**To: All Vendors Bidding on The College of New Jersey
STEM MEP Modifications Project**

ADDENDUM NO. 1

REFERENCE: The College of New Jersey
STEM MEP Modifications Project
Bid No. AB190029

6 Typical Unit Heater/Cabinet Unit Heater Control Diagram
 M705/ NO SCALE

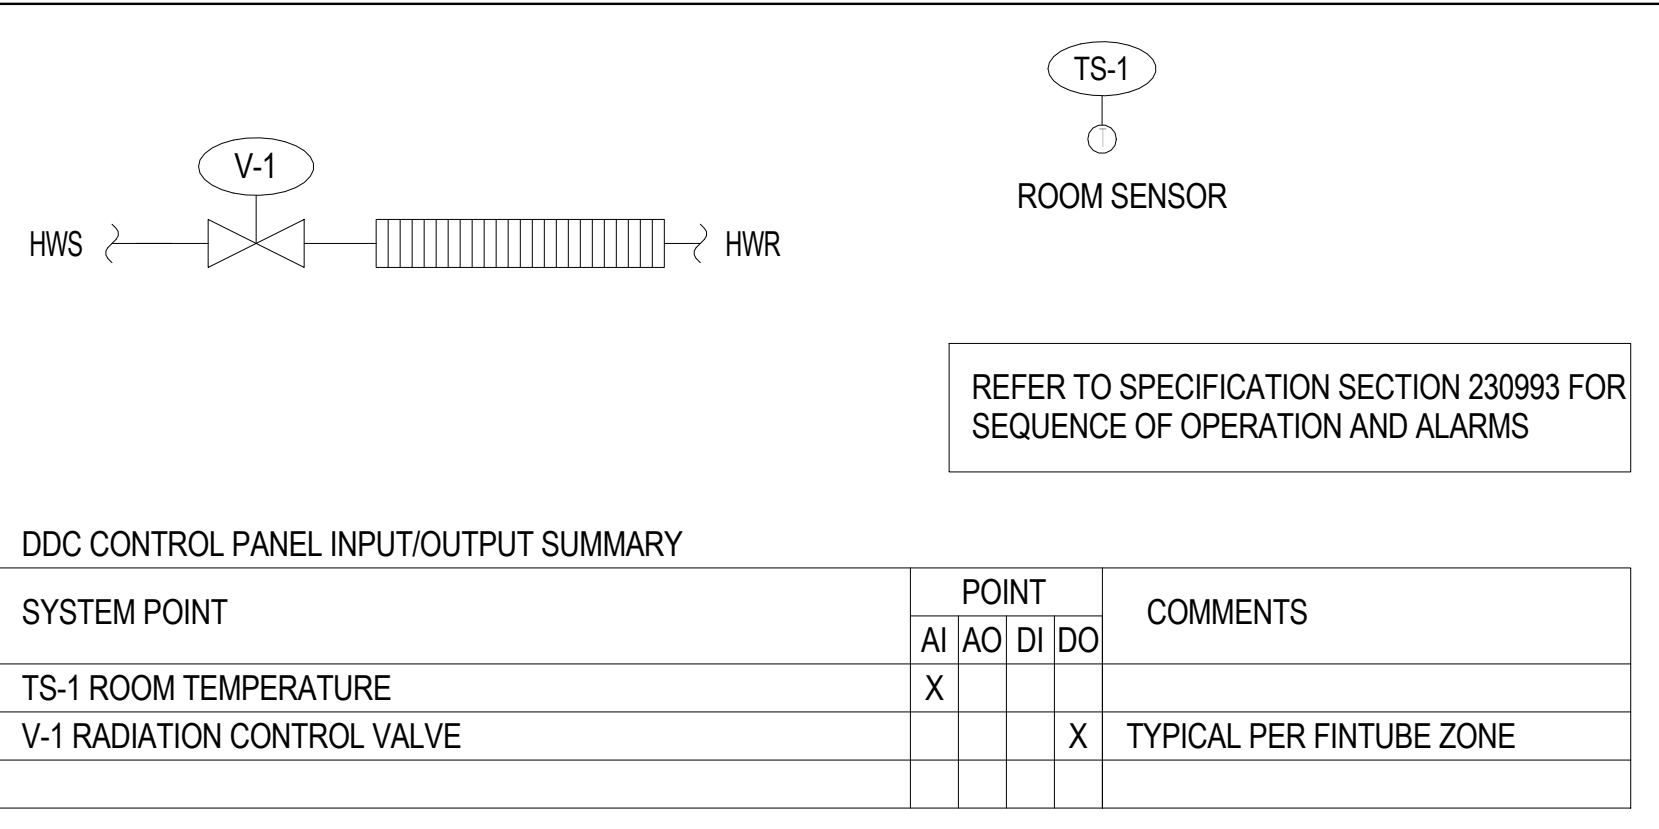
7. Bulletin #28 refers to drawing M705. There is no drawing M705 in bid package?

Answer: See attached sheet M705.
